**4131 BROOKLYN AVE NE**  
SEATTLE, WA 98105

SDCI Project #3034272-LU | RECOMMENDATION MEETING #2 | Meeting Date: March 14, 2022

TYPICAL TOWER WINDOW TYPES AND PATTERN

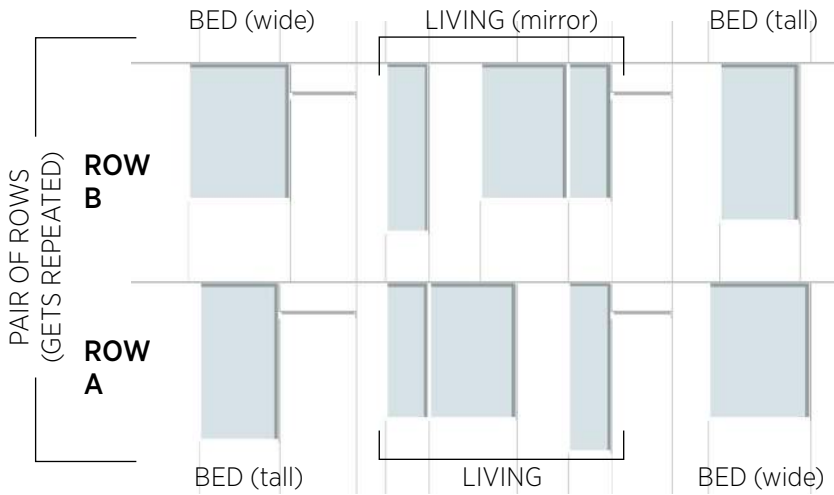
**b.2** The Board noted that this metaphoric effect might be strengthened through a reductive process (e.g., less variation in window types) that simplified and refined the texture.

**b.2** Both the window type/patterning variation and the shimmering color/texture contrast have been simplified and reduced.

The windows now have a living room expression and a bedroom expression, with subtle alternation for interest to help mitigate scale. As before, the alternating windows are paired into a group of two rows but this group is now simply copied up the tower facade as opposed to being further altered with each copy as before.

Subtle window variety helps break down the scale and activate the facade. Variation is created by alternating tall-narrow shapes with short-wide shapes, reflecting a pattern found in the Connector. The number of main window types has been reduced to 3 for the majority of the building.

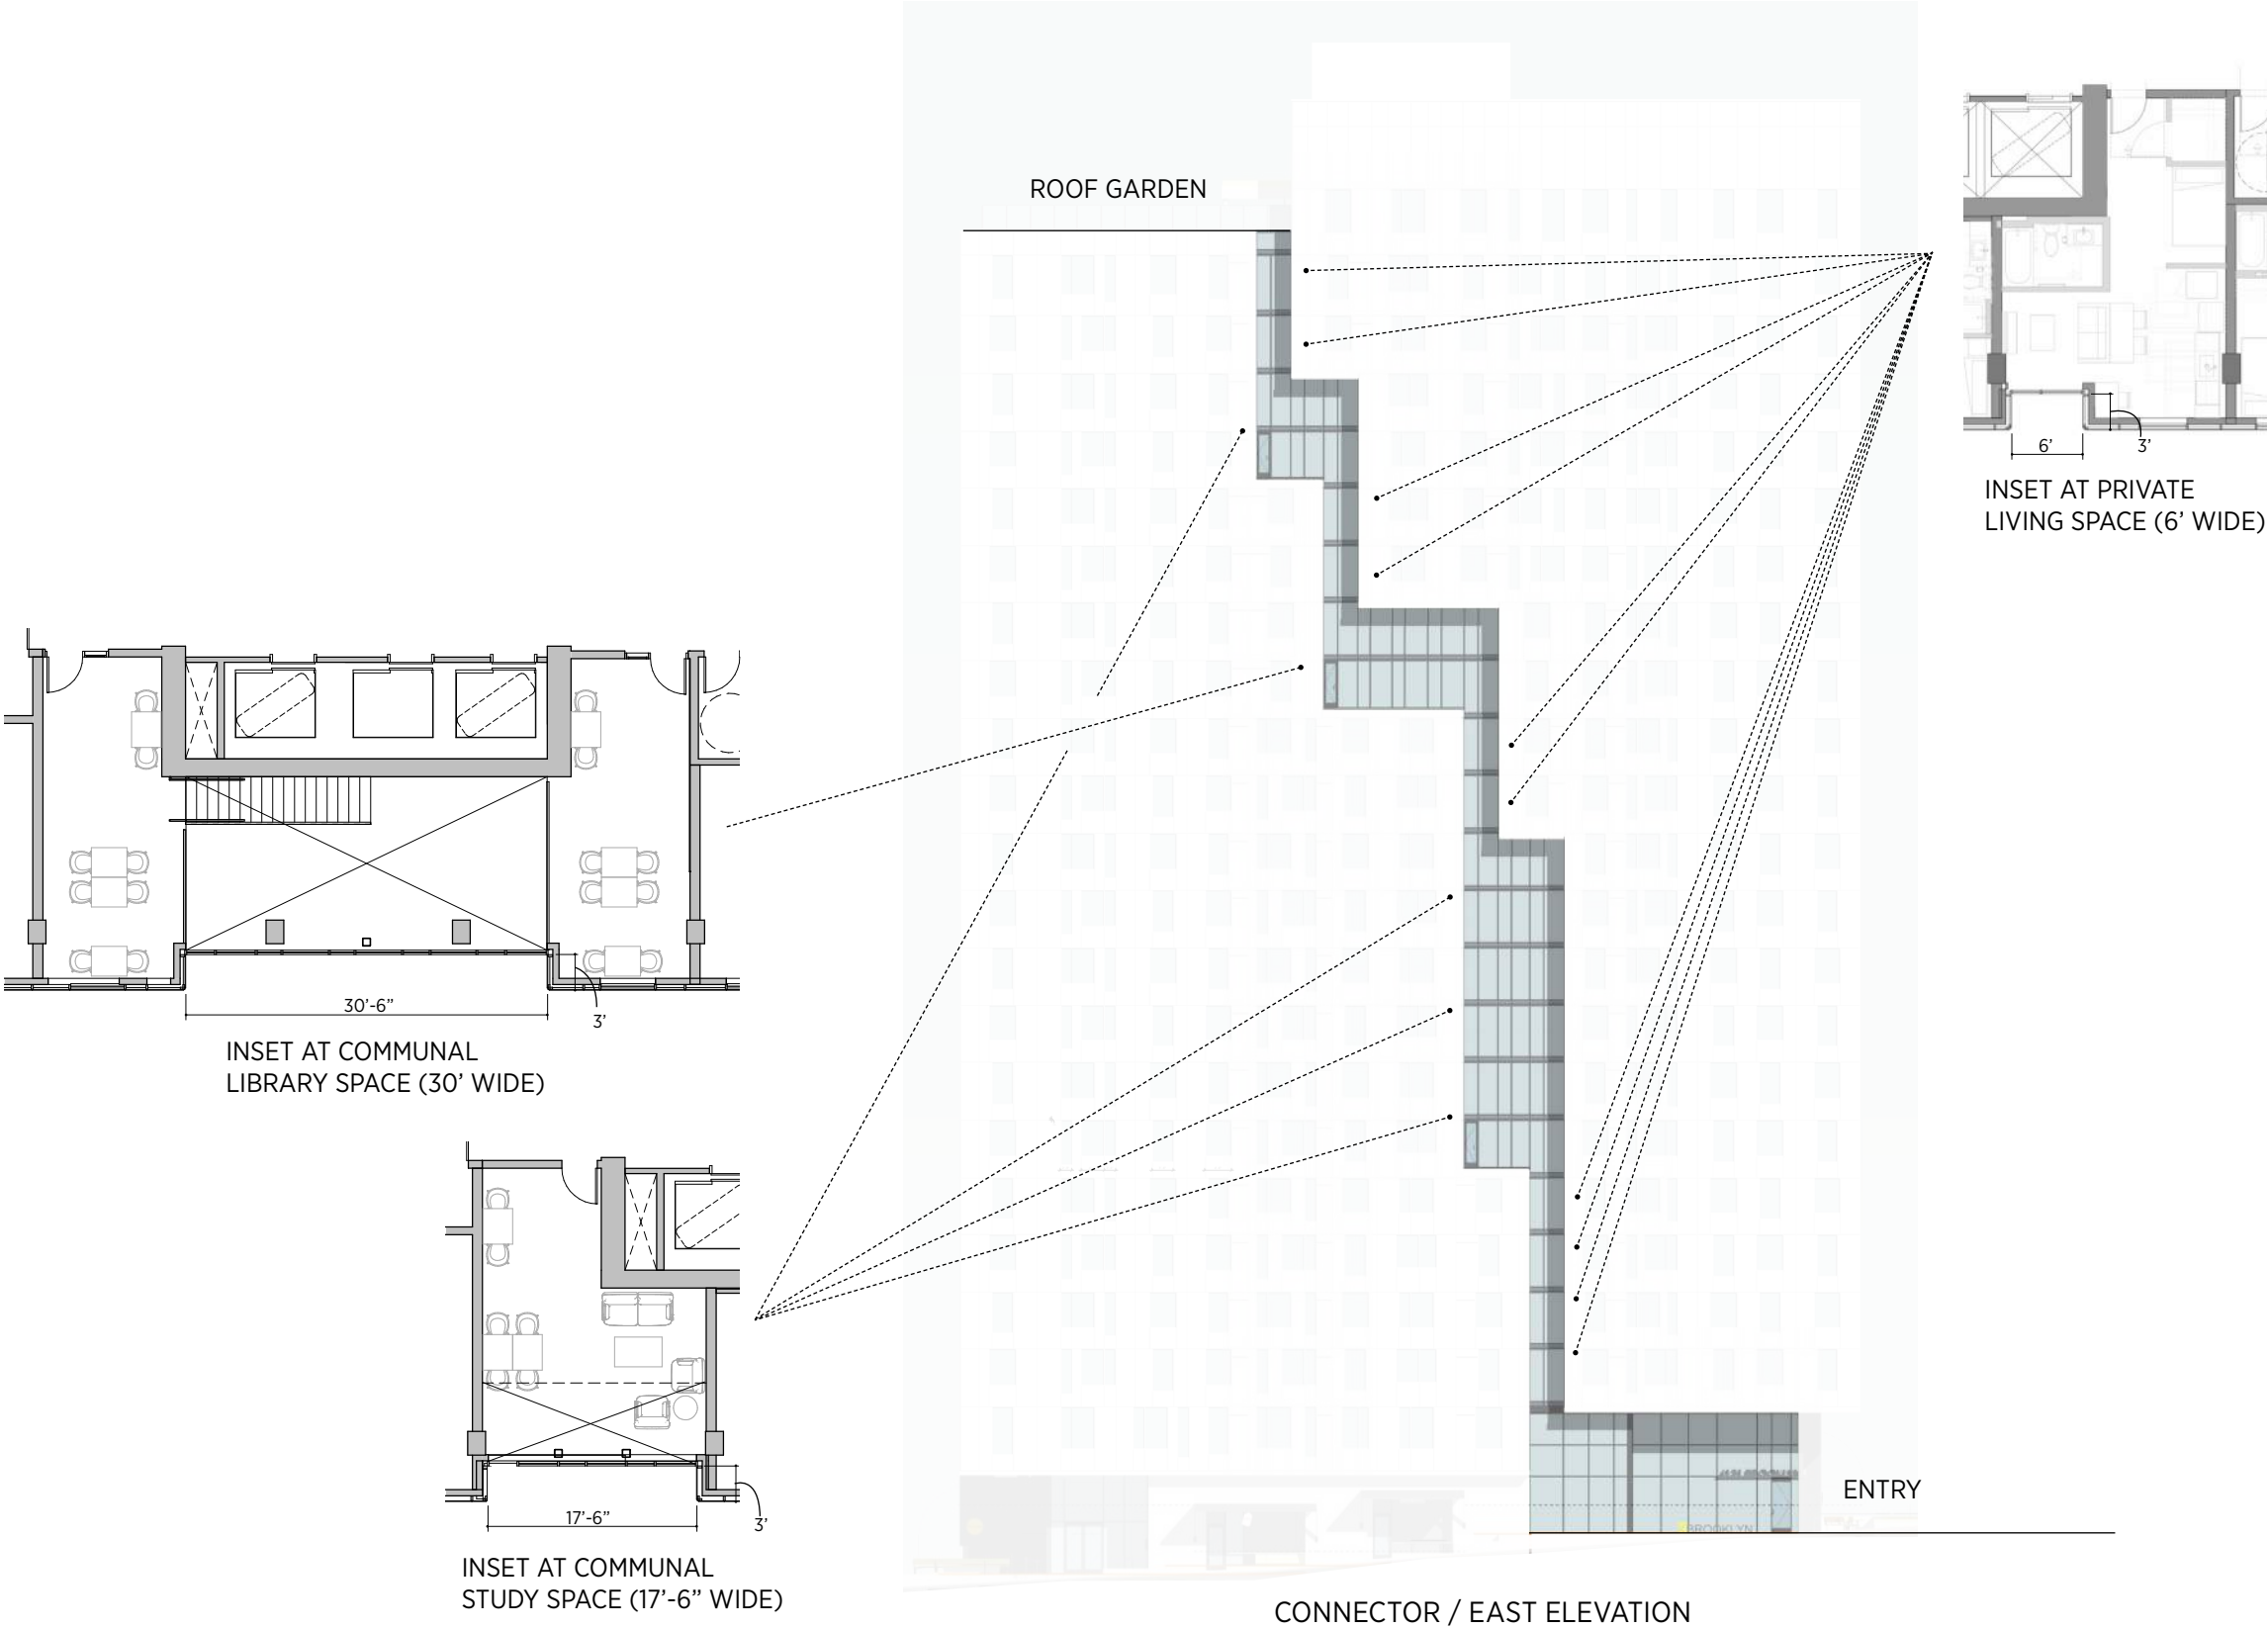
c. The Board supported the formal execution of the design concept on the East elevation, where full glazing and a significant plane change make the Connector element clearly legible. The Board encouraged increasing the size and strengthening the expression of the Connector so that it will read more as a distinct spatial element rather than a fissure between two massing components.

c. The street-facing Connector has been made more obvious from afar by adding 4 levels of double height expression to the facade's lower portion (equivalent to a 20% increase in tower Connector expression), thus revealing more of the interior social gather space.

The Connector's irregular shape and continuous expression from ground to sky still take inspiration from the informal in-between spaces of the district and the pedestrian paths' flow through them. However, the variation in width of the Connector's expression is now more directly tied to the internal functioning, with wider areas of inset glass being double height gathering spaces and narrower areas being more intimate living spaces. This link of form and function is true for both the East and the West facades.

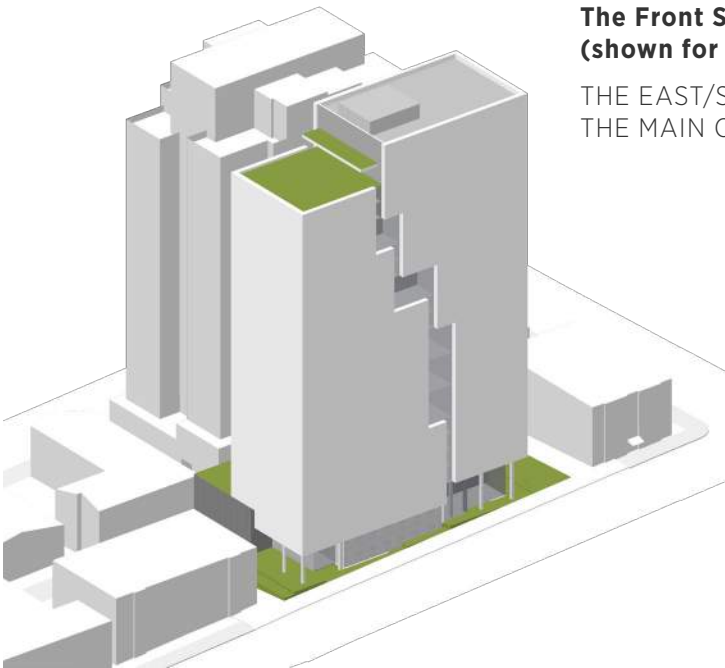
e. The Board recognized the change in programming between the East and West facades and the complexity this brought to the expression of the design concept on the West façade. The Board suggested the applicant the following, in order to resolve this challenge:

e.1 Strengthen the legibility of the Connector on the West facade with a more distinct material expression and larger planar offset that works to help distinguish and articulate the two roof levels.

e.2 Explore a new solution consistent with the overall design concept while recognizing the lack of the programmatic ‘Connector’ elements on this facade.

e.3 Explore a solution that mitigates the scale of this facade by creating legible hierarchy and depth, shadow and texture in the cladding system.

Before arriving at the proposed design of the Alley facade, several versions were studied to address the Board’s guidance.

While other versions have certain strengths, the proposed design best adheres to the design concept of a continuous Wrap surface opening up to an East-facing social Connector, while also providing a vertical massing break at the top of the tower which relates to the neighbor tower’s verticality and also addresses the double-height rooftop step where the neatly-enclosed amenity/mechanical penthouse meets the south-facing roof deck.

NORTH PLAZA AT REC 1

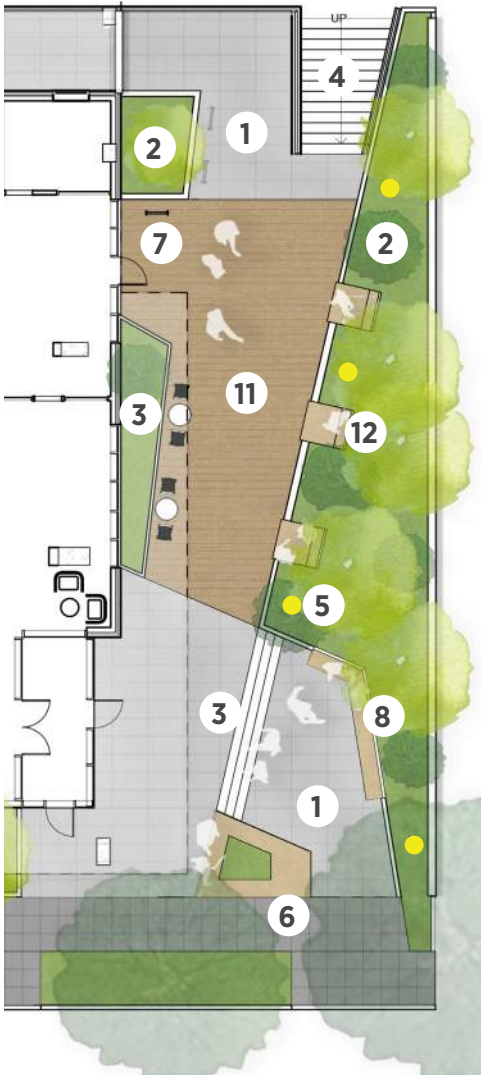
a. The Board recognized the requirement that the North Plaza provide publicly accessible neighborhood open space and agreed that in the current proposal this area appeared privatized, conflicting with the requirement and Design Guidelines.

b. The Board recognized that some of the North Plaza area must be dedicated to circulation but expressed concern that in the current design the Plaza appeared too much like pass-through space. The Board agreed that the size of the active use areas should be increased and clearly defined and articulated to encourage use and to clearly convey their potential use as neighborhood gathering space.

a. The North Plaza is designed to appear more open and inviting to the public for their use.

b. Active use hardscape areas have been increased and are now more open to the sidewalk. The new design has 10% more pedestrian area in a more open arrangement. It also has 36 percent more linear feet of built-in seating arranged in a more integrated manner from the sidewalk to the alley stairs.

SITE CIRCULATION PLAN  
SHOWING NODES OF ACTIVITY

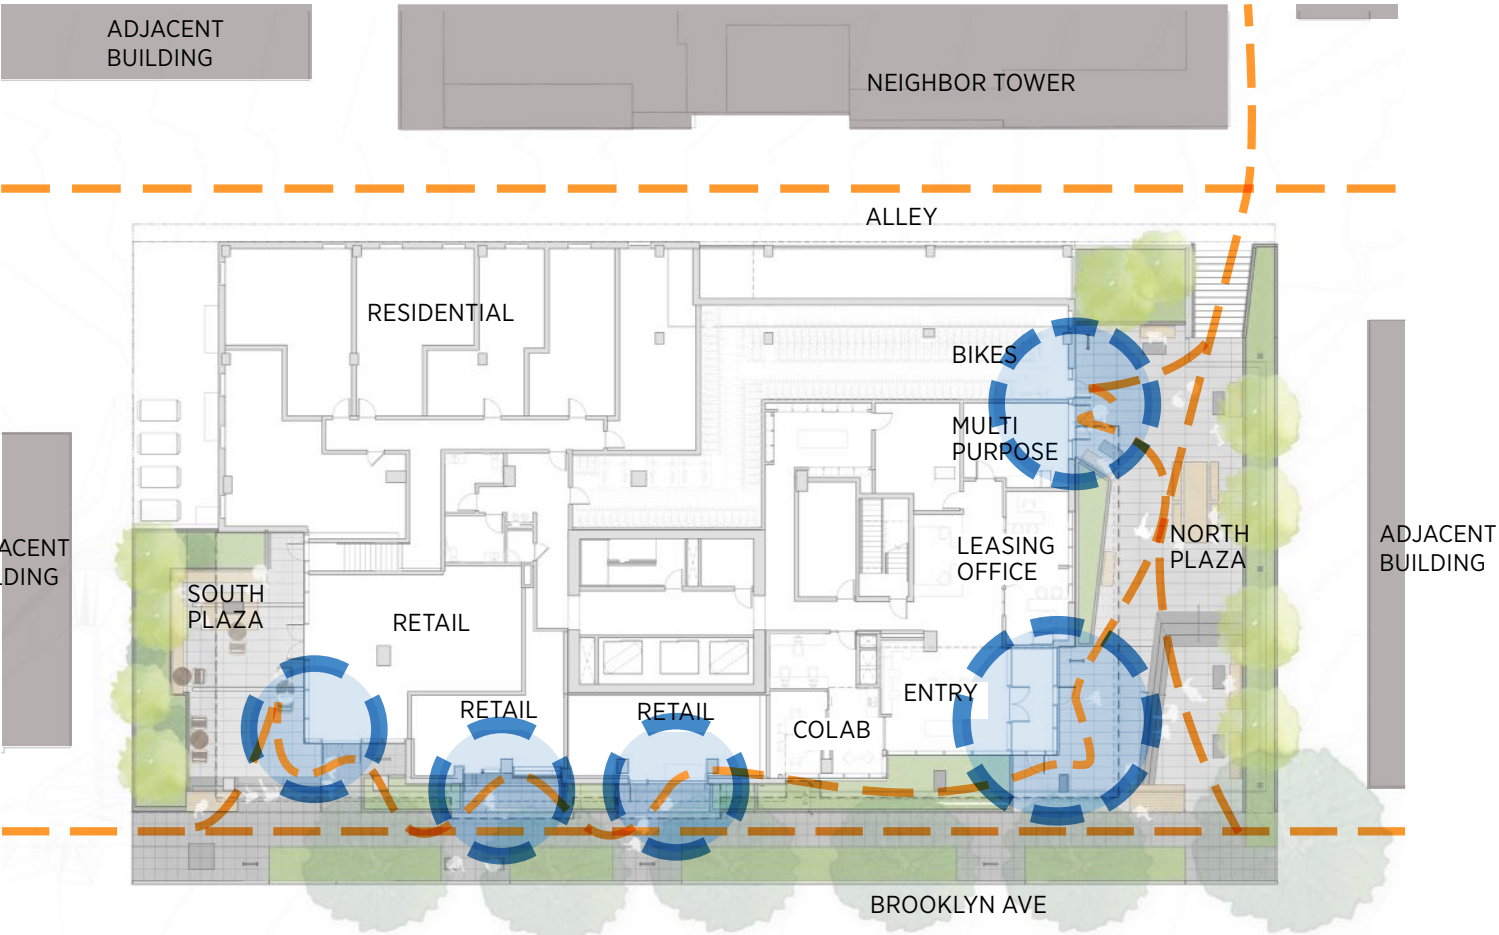
- e. Echoing public opinion, the Board did not support the large lobby area facing the street and questioned the level of activity that would be generated by the leasing offices. The Board agreed that active uses should be programmed at the edges of both the street and the North Plaza area to encourage human interaction and activity.
- f. The owner stated their intention to bring the activity and architectural expression of the Connector element to the street edge and this was supported by the Board.

e, f. In addition to Brooklyn Ave’s ground level South Plaza and (non-req’d) retail space, the entry lobby, as the start of the Connector, plays an important role in linking the tower’s upper levels to the ground level outdoor space. In addition to a minimized leasing area and a more prominent bicycle area, the activity of the lobby and its associated colabration spaces will enliven the street edge with the most pedestrian traffic of any place on site.
